VIEW A

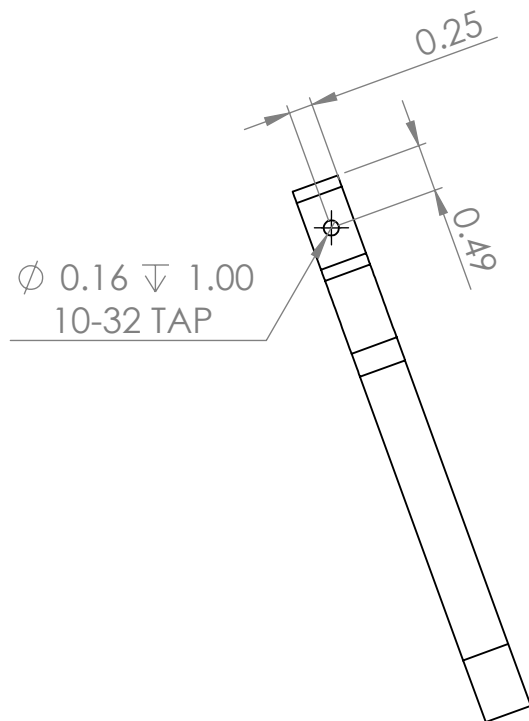
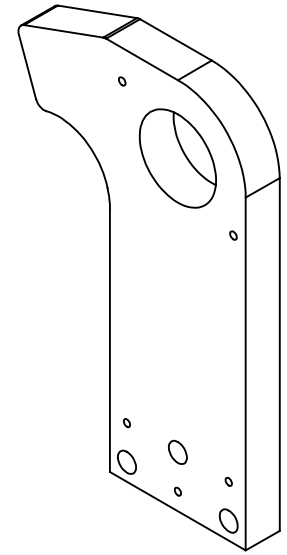
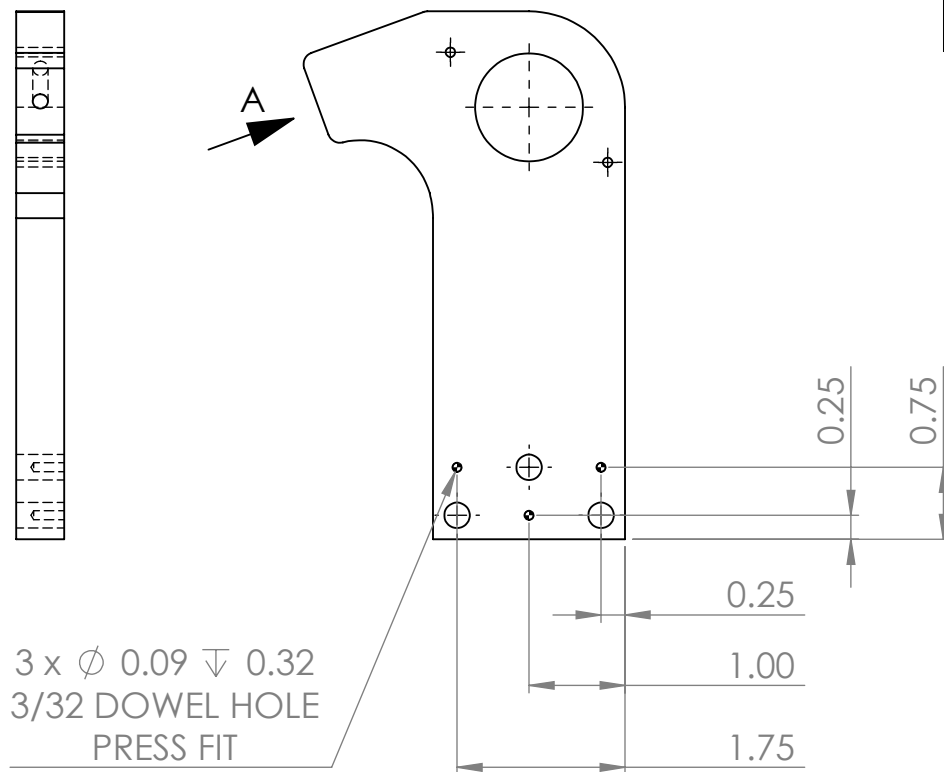
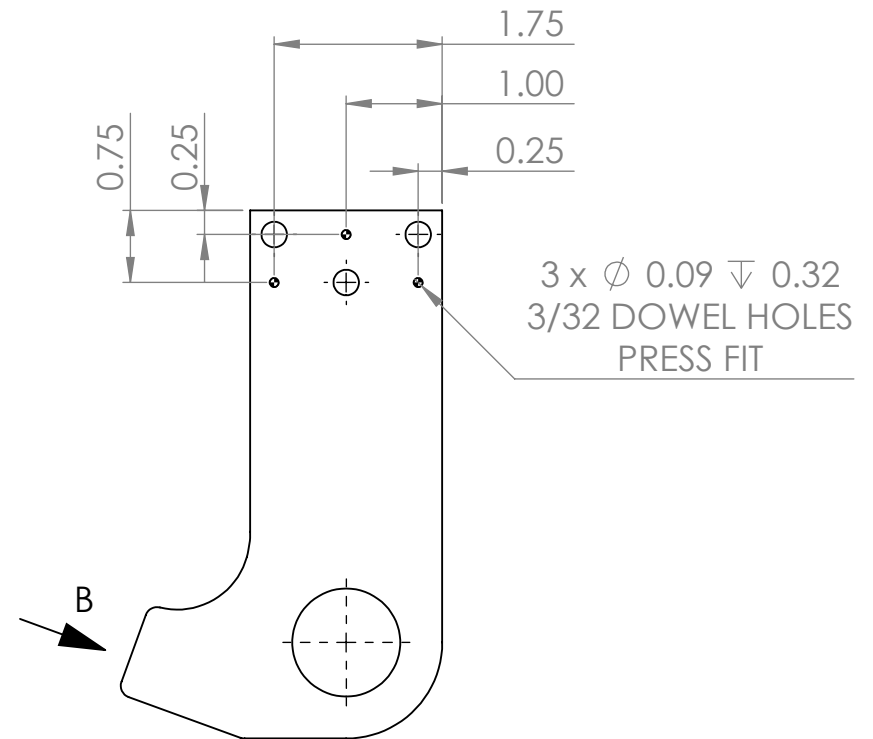
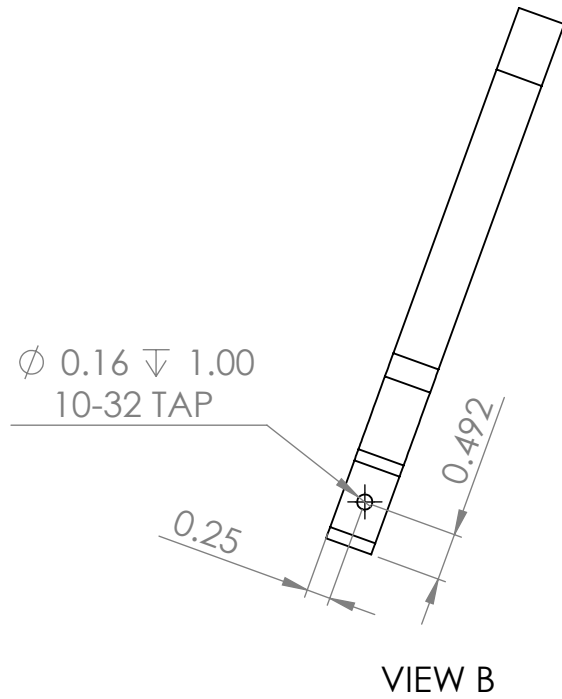
THERE ARE 2 OF THESE  
 THIS ONE HAS HOLES FOR ENCODERS  
 THE OTHER ONE DOES NOT  
 BLIND DOWEL PIN HOLES SHOULD BE MIRRORED ON THAT PIECE

NO ENCODER SIDE  
 BLIND DOWEL HOLES ARE MIRRORED
